SERVICE BULLETIN

Classification: BT10-004	Reference: NTB10-014	Date: January 26, 2010
-----------------------------	-------------------------	---------------------------

2009 370Z COUPE; REAR HATCH WILL NOT OPEN ON FIRST PUSH OF RELEASE BUTTON

APPLIED VEHICLE: 2009 370Z Coupe (Z34)
APPLIED DATE: Vehicles built before October 6, 2009

Figure 1

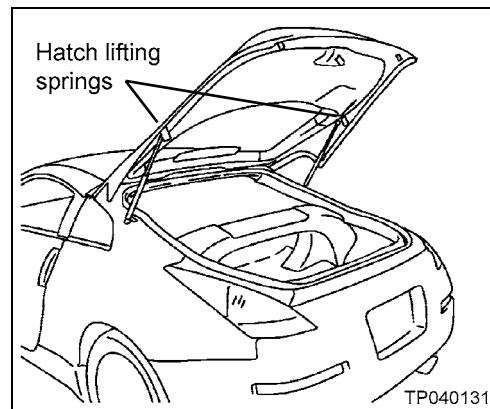
2. Open the rear hatch.

NOTE: You may have to pull up on the hatch while pressing the release button.

Figure 2

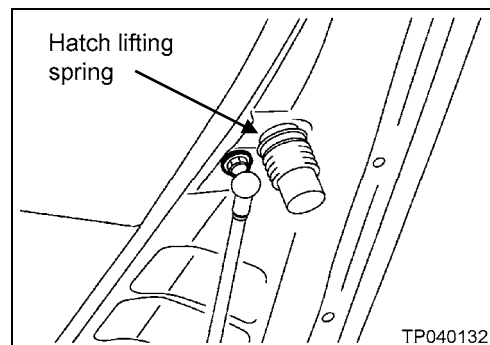
3. Replace the rear hatch lifting springs.
 - Use the new springs listed in the Parts Information section.
 - Remove by turning the springs $\frac{1}{2}$ turn in either direction.
 - Install in reverse order.

Replace the rear hatch lifting springs with the new ones listed in the Parts Information section.

DESCRIPTION	PART #	QUANTITY
Spring-lift	84415-1EA1E	2
